Access Compliance Report

Public Rights-of-Way

(Curb Ramps)

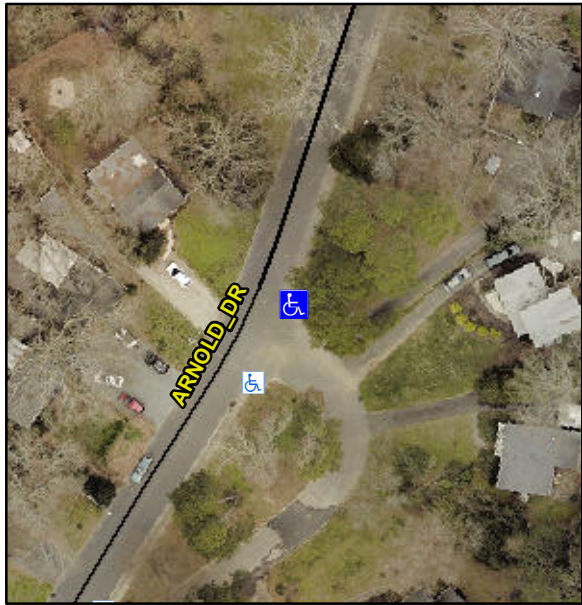
Intersection ID: 10012781	Main Street: ARNOLD_DR	Cross Street: N/A	Location: NE
ADA ID: 7BE4F46A69A8	Ramp Type: PerpDiag	Initial Pass/Fail: Fail	Overall Compliance: No
Severity Score: 8.75			
Codes/Mitigation Info/Possible Solution		Field Measurements/Component Compliance

Compliance	Description	Data	Compliance	Description	Data
N/A	Ramp Length (in)	41.0	Yes	Ramp Slope (%)	5.9
No	Ramp Width (in)	36.0	Yes	Ramp XSlope (%)	1.9
N/A	Flare Type LT	N/A	N/A	Flare Type RT	N/A
N/A	Flare Slope LT (%)	N/A	N/A	Flare Slope RT (%)	N/A
N/A	Flare Traversable LT?	N/A	N/A	Flare Traversable RT?	N/A
N/A	Landing Length (in)	N/A	N/A	DWS Provided?	N/A
N/A	Landing Width (in)	N/A	N/A	DWS Contrast?	N/A
N/A	Landing Slope (%)	N/A	N/A	DWS Length (in)	N/A
N/A	Landing X Slope (%)	N/A	N/A	DWS Full Width?	N/A
N/A	Landing Curb? (Y/N)	N/A	N/A	DWS Offset (in)	N/A
N/A	Shared Landing?	N/A			
N/A	Gutter Ponding?	N/A	N/A	Gutter Slope (%)	N/A
N/A	Gutter Lip Ht (in)	N/A	N/A	Gutter X Slope (%)	N/A
N/A	Painted X Walk1?	No	N/A	Painted X Walk2?	No
	X Walk 1 Direction	To W		X Walk 2 Direction	To SW
N/A	X Walk 1 Width (in)	N/A	N/A	X Walk 2 Width (in)	N/A
	X Walk 1 Slope (%)	1.6		X Walk 2 Slope (%)	0.6
	X Walk 1 X Slope (%)	0.2		X Walk 2 X Slope (%)	2.8

Remove & Replace Curb Ramp With Two New Directional Ramps or Equivalent.
